Harrogate Cycle Action Questions & Response to Otley Road/Pannal Ash Road Consultation

Otley Road

Shared use option

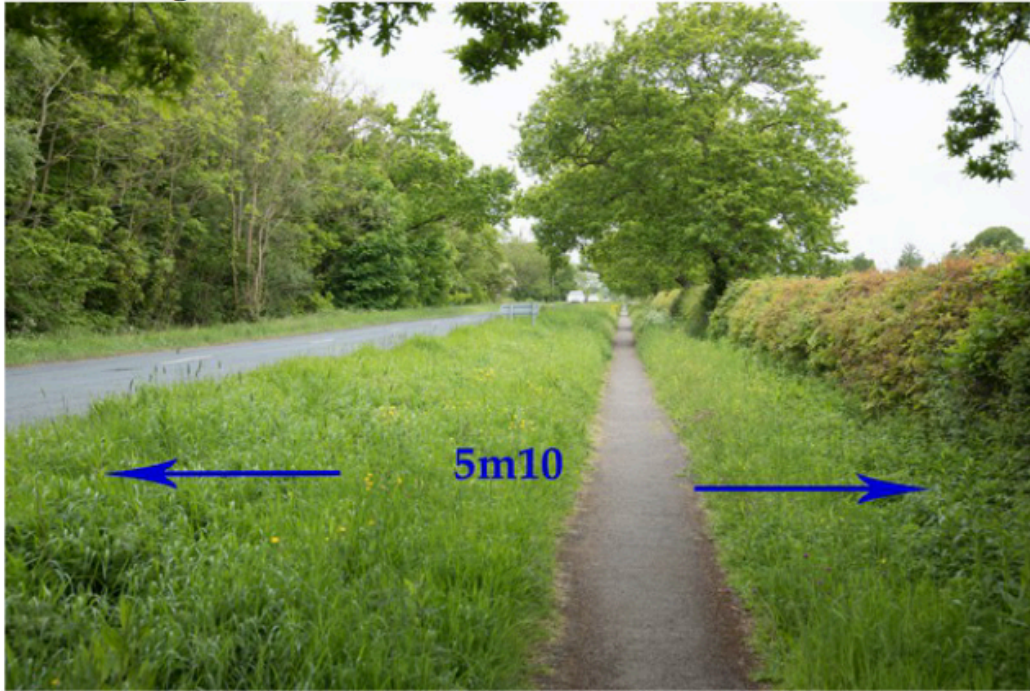
Shared use is unlikely to see an uptick in active travel when considering the planned large scale residential development to the west of the scheme, and the inclusion of the scheme on Harrogate's Primary LCWIP corridor. LTN 1/20 chapter 5.5.3 suggests that footway conversion into shared use should only be considered when options that reuse carriageway or verge have been rejected.

To ensure continuity along the route consider narrowing carriageway on western extent of scheme to allow for continued width throughout'
